**THE CITY OF THE VILLAGE OF DOUGLAS
PLANNING COMMISSION MEETING
THURSDAY, JULY 11, 2024 AT 7:00 PM
86 W CENTER ST., DOUGLAS MI**

To: City of the Village of Douglas Planning Commission
Date: July 5, 2024
From: Sean Homyen, Planning & Zoning Administrator
RE: 319 Ferry St – Proposed Multi-Family Development

On behalf of the City of Douglas, our office has reviewed the *revised* drawings dated *June 12, 2024* and received *July 3, 2024* for the above referenced project. Our comments regarding the project are as follows: *A previous review was completed on March 11, 2024; the comments corresponding to this review are in blue italics.*

SHEET NO:
L-100

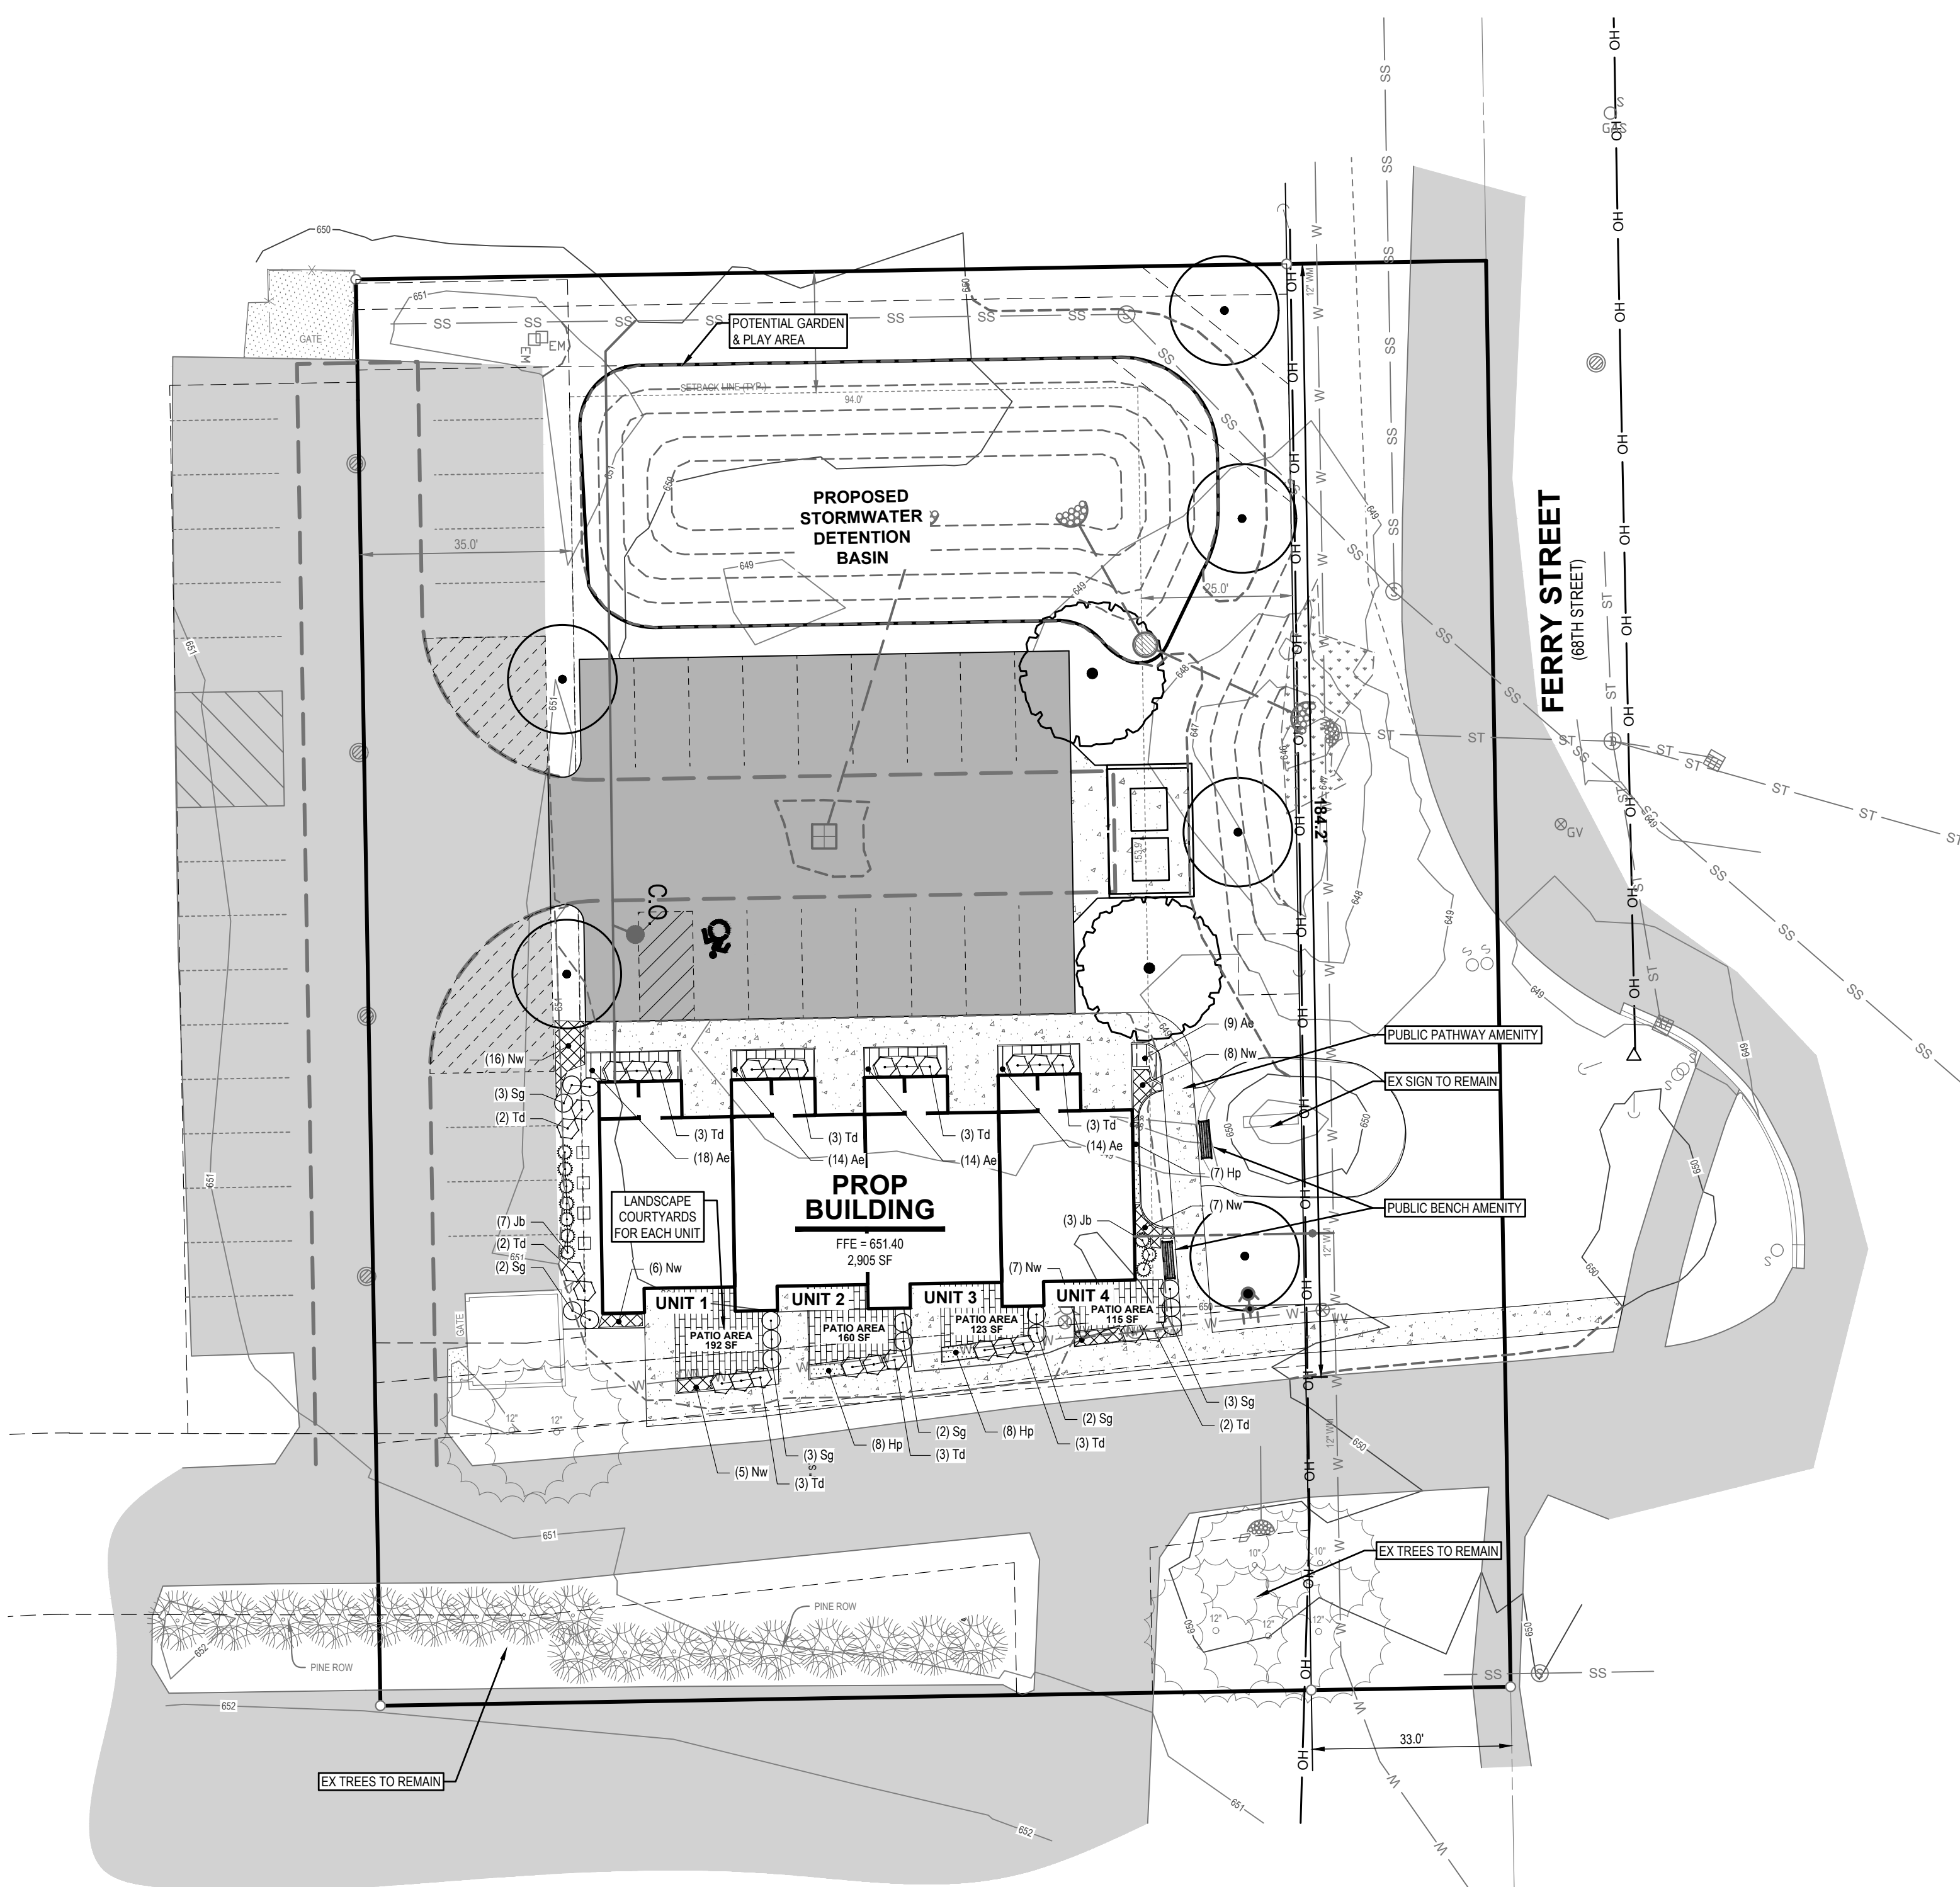
16. *Patio areas and plantings are proposed over the existing water main and within the easement area. The City nor KLSWA should be responsible for replacement of these improvements if a repair or replacement is needed on the water main. (See L-100)*
